# TECHNICAL BULLETIN

[Issue No.] T05-0007

[Title] Cautions when using the QY22 TRIAC output module

[Relevant Models] QY22

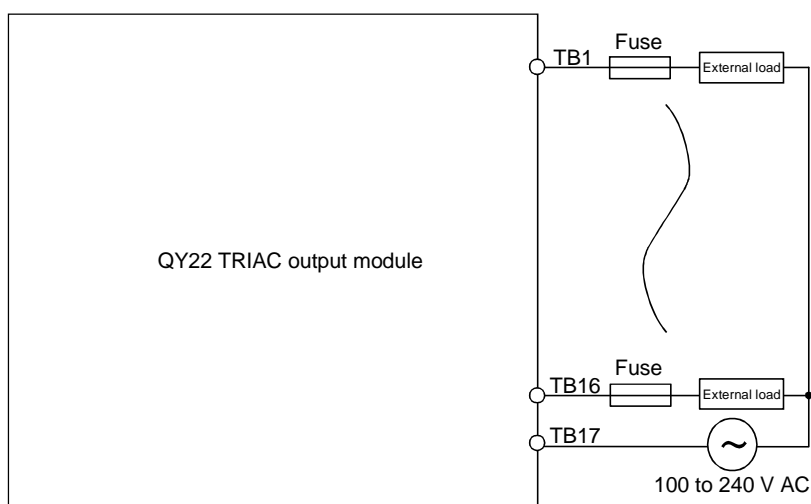
External devices or module may burn out, if a short occurs while the module is in operation.

It is recommended to install the IEC60127 sheet I-compliant fuse to each external terminal of the module as follows.

Mitsubishi recommends the following fuses.

Fuse Model	216 02.5	216 002
Rated current	2.5A	2A
Manufacturer	Littelfuse, Inc
